SERVICE BULLETIN

Exchange of floats (pair) on ROTAX® Engine Type 912 and 914 (Series)

ATA System: 73-00-00 Fuel system

APPENDIX TO
SB-912-074 / SB-914-056 (+UL)

Fig. 2

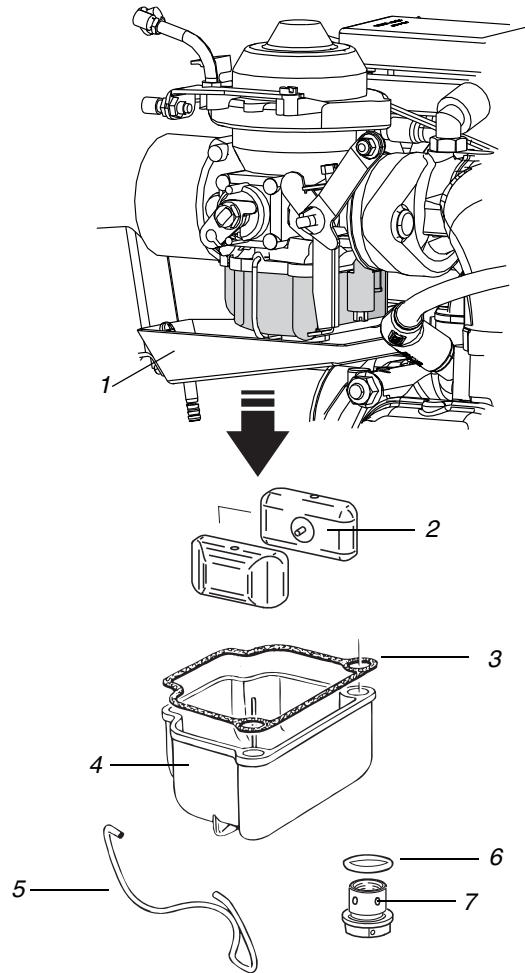
3.5.2) Removal of float chamber

Step	Procedure
1	Remove drip tray (1), if installed.
2	Visual inspection of the carburetor and its mechanical actuation.
3	Remove spring clip (5) or for ROTAX® 914 Series remove safety wire, loosen cap screw (7) and remove with O-ring (6).
4	Remove float chamber (4), gasket (3) and the two floats (2)

Step	Procedure
1	Replace the gasket (3) of the float chamber (4) and for ROTAX 914 Series replace the O-ring (6).
2	Install float chamber (4) with gasket (3) and both floats (2).
3	Close spring clip (5) or for ROTAX 914 Series install the attachment screw (7) including O-Ring (6). Tightening torque of attachment screw 5.5 Nm (48.7 in.lb). Apply safety wire.
4	Install drip tray (1) and/or accessories according to the instructions of the aircraft manufacturer.

Fig. 3

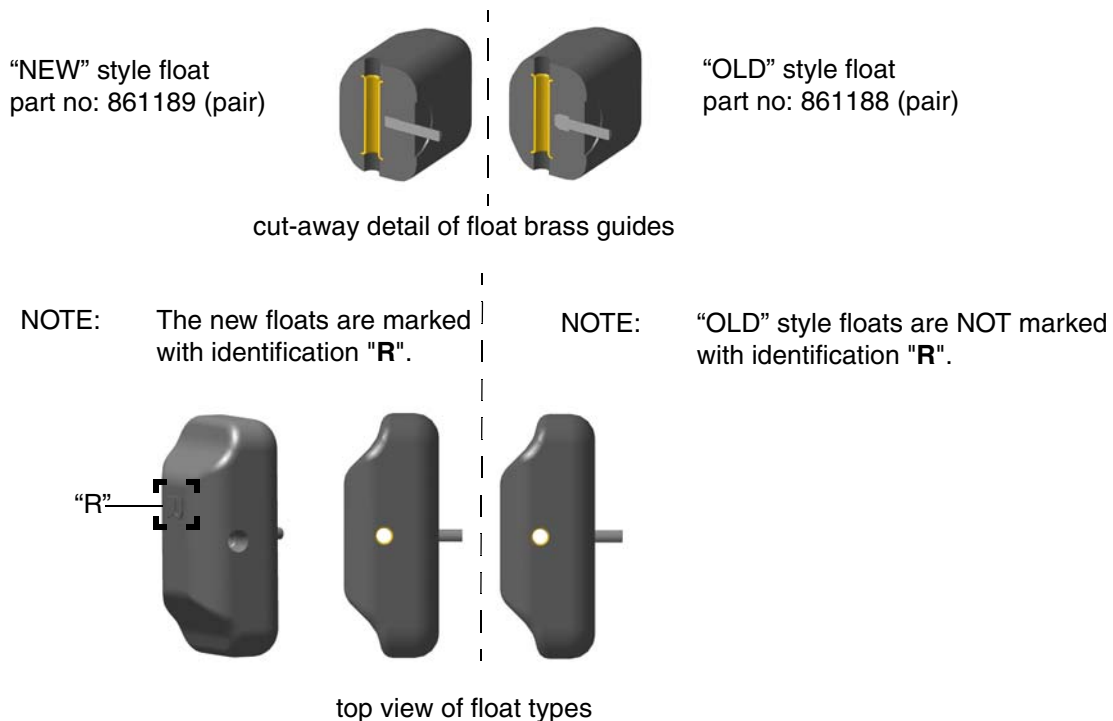
3.5.3) Check and/or exchange of floats

Perform visual inspection of style of float (see Fig. 3).

Style of float	Procedure
“NEW” style float part no. 861189 (pair)	Do not need to be changed and can be reused; go to section 3.5.4.
“OLD” style float part no. 861185 or part no. 861188 (pair)	- Exchange of the floats must be carried out according to the latest Maintenance Manual Heavy (MMH) - Replace them with part no. 861189 and go to section 3.5.4

NOTE: For carburetors, service kits carburetor, maintenance kit carburetor, overhaul kit etc. replace affected floats part no. 861185 and 861188 with floats part no. 861189 (see [Fig. 3](#)).
